**This document includes extended narratives for all resources, please see the 20190118 Comments Table to determine which narrative applies to a specific resource.**

## **Extended Narratives**

**Figure 5-94B. Glen Canyon Dam Release Temperature Percentiles for the LPP Proposed Action**

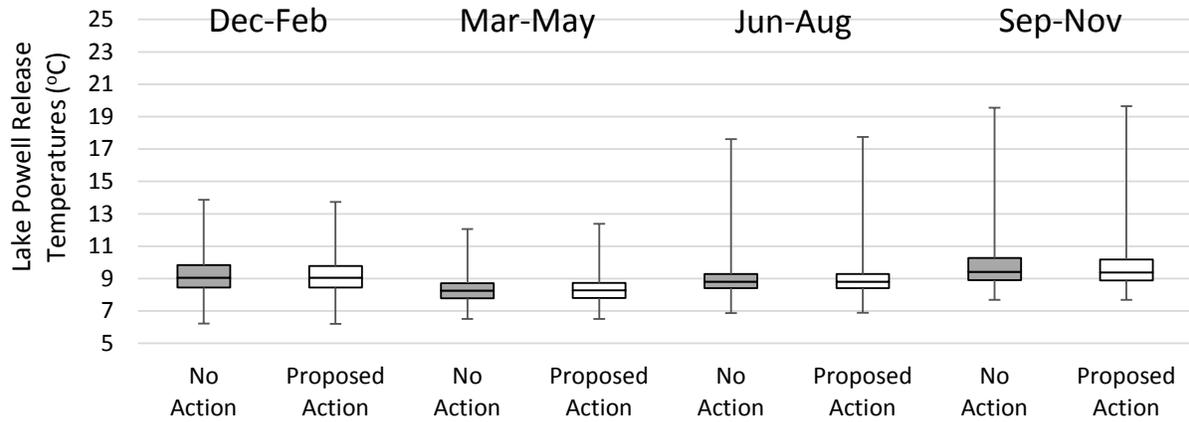
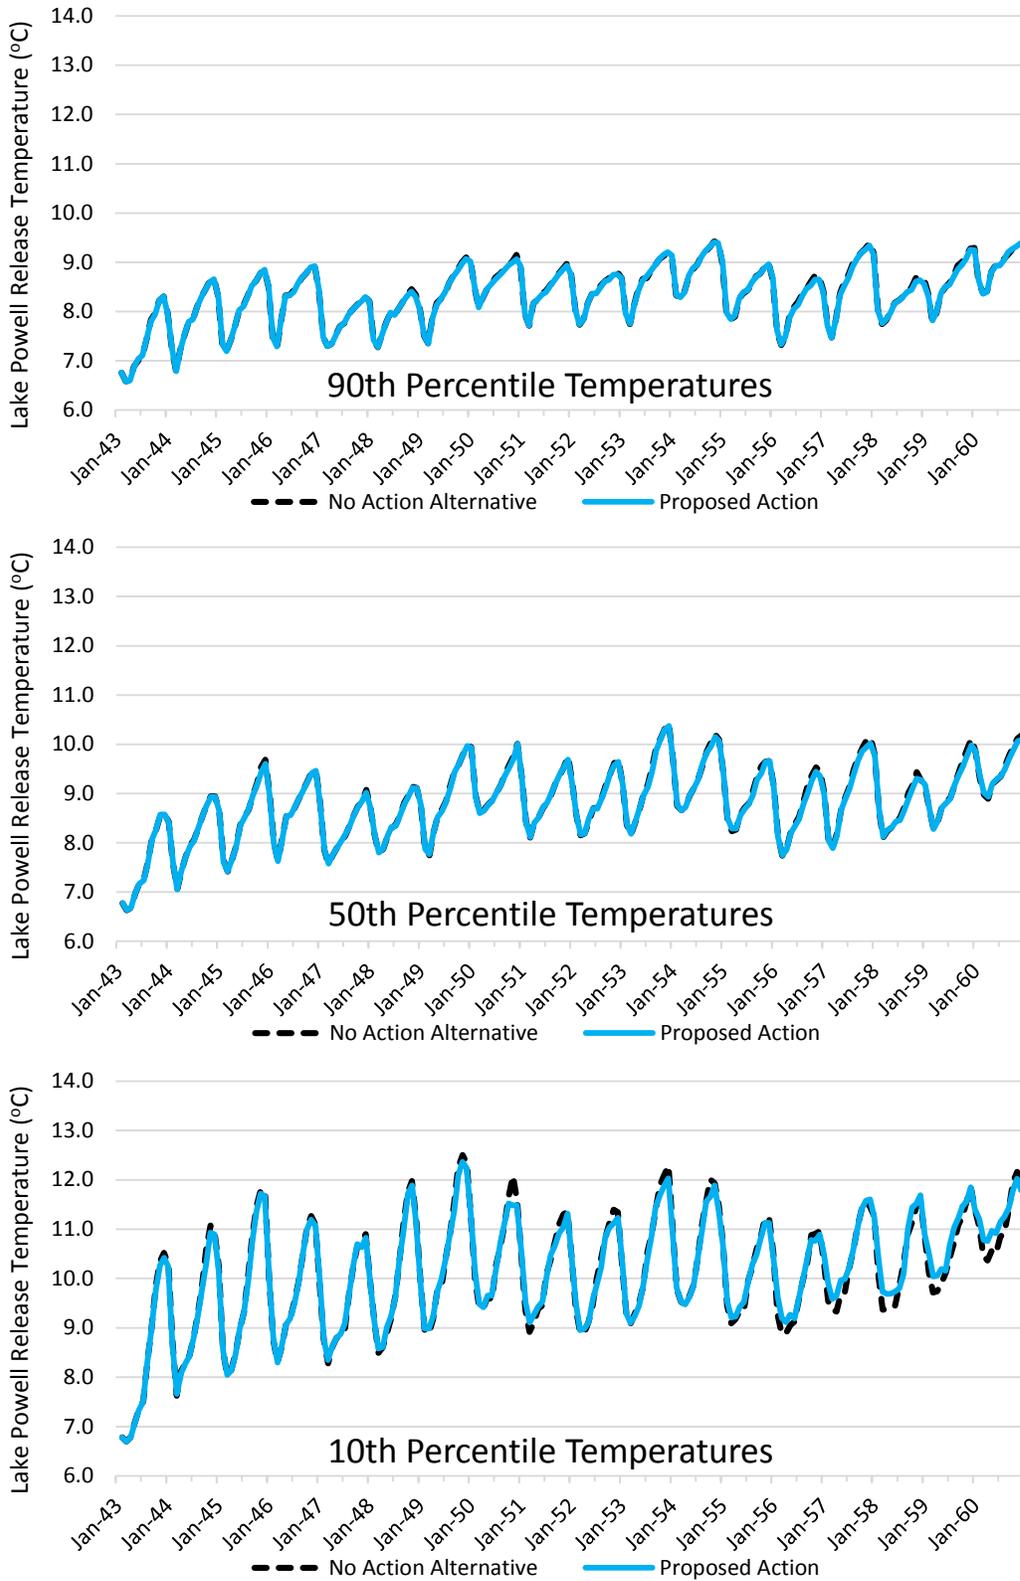
Glen Canyon Dam release temperatures often peak in October and simulated results show that when the reservoir is at or near full pool elevations, as was the case from 2050 to 2056, water temperatures of releases from the dam for the Proposed Action scenario were colder than in the No Action alternative scenario. The release temperatures from the dam in the pipeline scenarios are colder when the reservoir is near full capacity because of the removal of warm water from the upper, warm layer of the reservoir by the pipeline. Simulated release temperatures for the Proposed Action scenario were warmer than the No Action alternative scenario during summer and fall months when reservoir pool elevations were below full pool.

The largest differences between the Proposed Action scenario and the No Action alternative scenario for all 100 traces coincided with drier conditions and lower reservoir pool elevations (see 10<sup>th</sup> percentile temperatures in Figure 5-94B). Temperatures in wetter conditions (50<sup>th</sup> and 90<sup>th</sup> percentiles) are driven more by higher reservoir inflows and elevations, and less by small diversions. On average, the Trace 59 modeled results for the Proposed Action compared with the No Action alternative are within 0.1°C for the 2045-2060 period. For individual years, differences of up to 0.71°C were predicted (Reclamation 2016). For all 100 traces, average temperature changes between the Proposed Action and the No Action Alternative range between -0.1°C and 0.2°C. For individual months, differences range between -1.9°C and 0.5°C.

**Figure 5-94D. Glen Canyon Dam Release Temperature Percentiles for the LPP Proposed Action Under Climate Change**

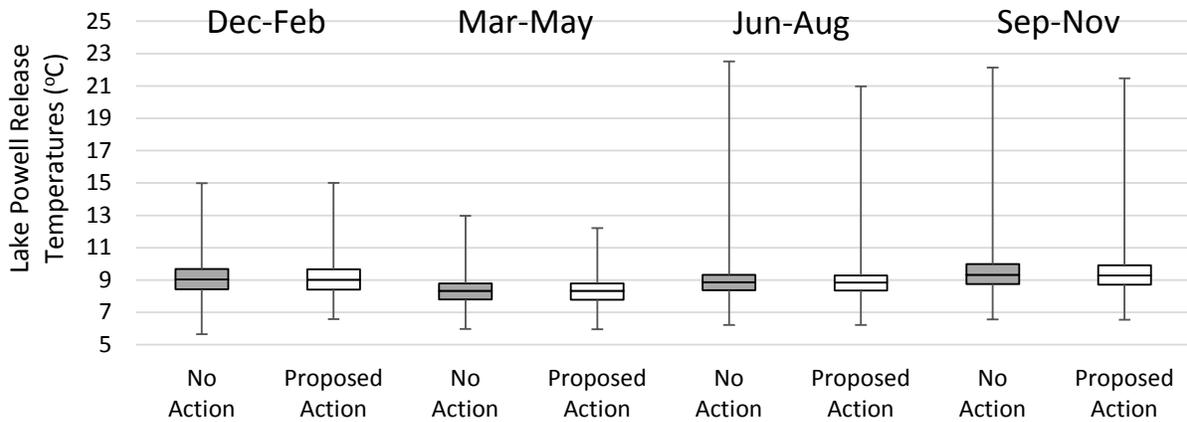
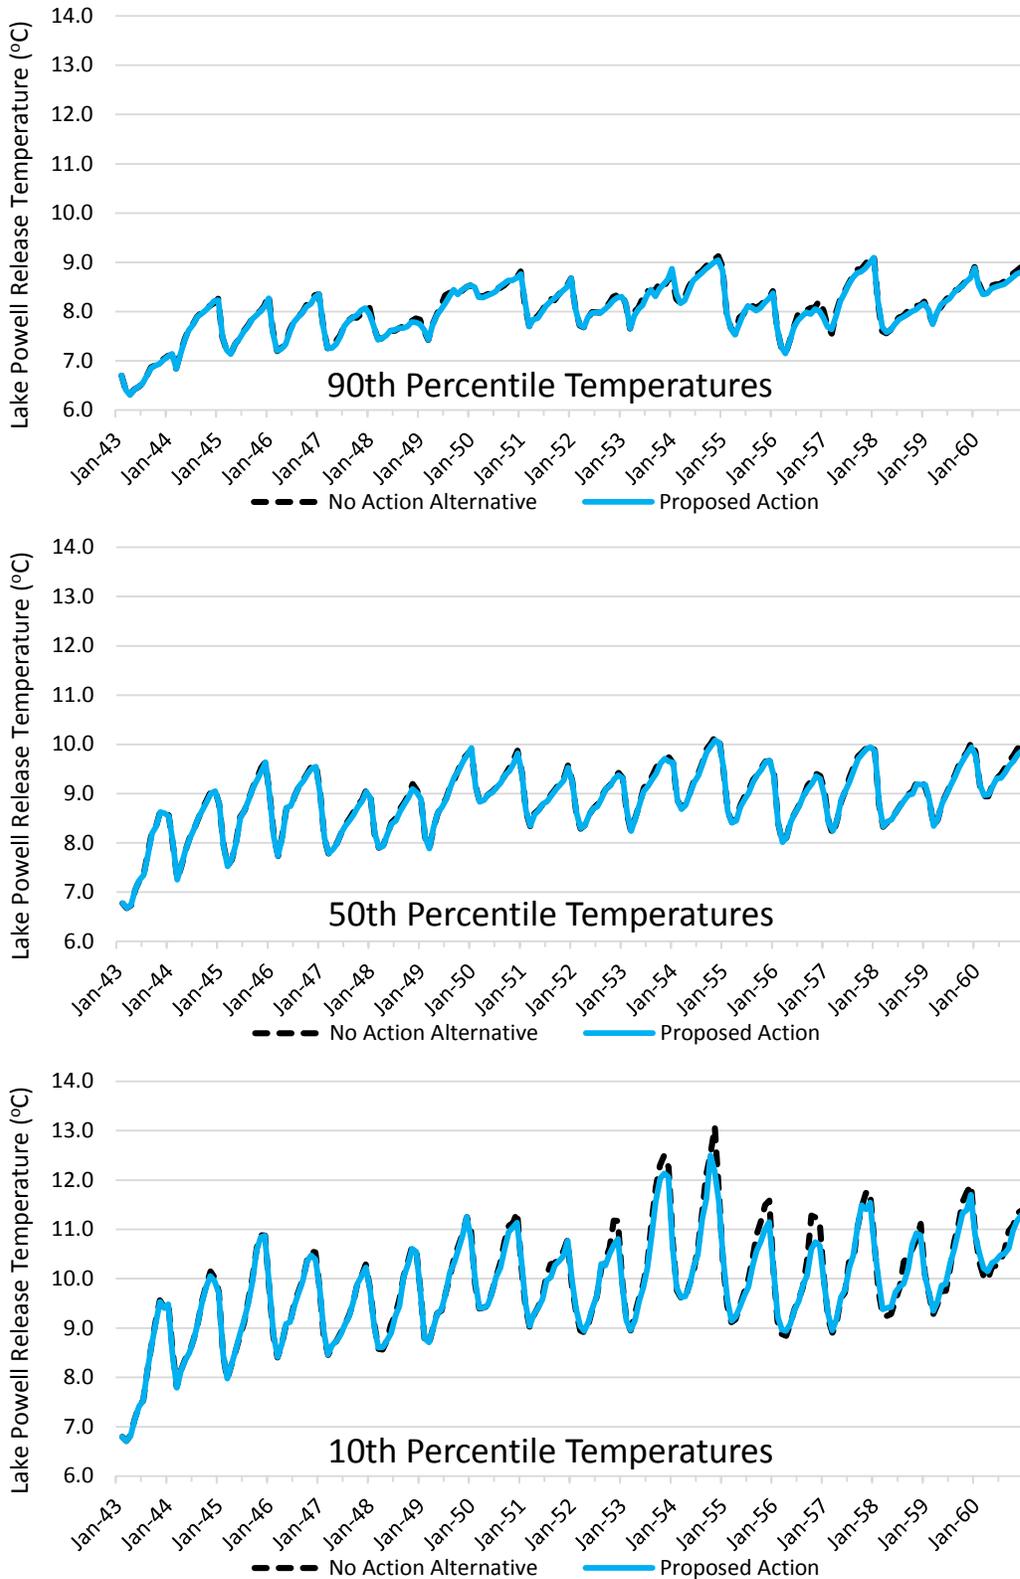
Low reservoir elevations below Lake Powell's normal operating range, resulting from 10th percentile climate change inflow hydrology conditions as modeled by Reclamation, would be lowered further by the combination of the LPP Proposed Action depletions and one or more of the listed interrelated actions. The climate change inflow hydrology would be the primary cause of the lowered reservoir elevation in Lake Powell, and the combination of LPP depletions and one or more of the other interrelated actions would further lower the reservoir level by 1.7 feet at the 10th percentile of climate change inflow conditions. Cumulative effects on surface water quality in Lake Powell would include increased and decreased water temperatures (Figure 5-94C), decreased

dissolved oxygen concentrations, and increased TDS concentrations. These cumulative effects would be significant.
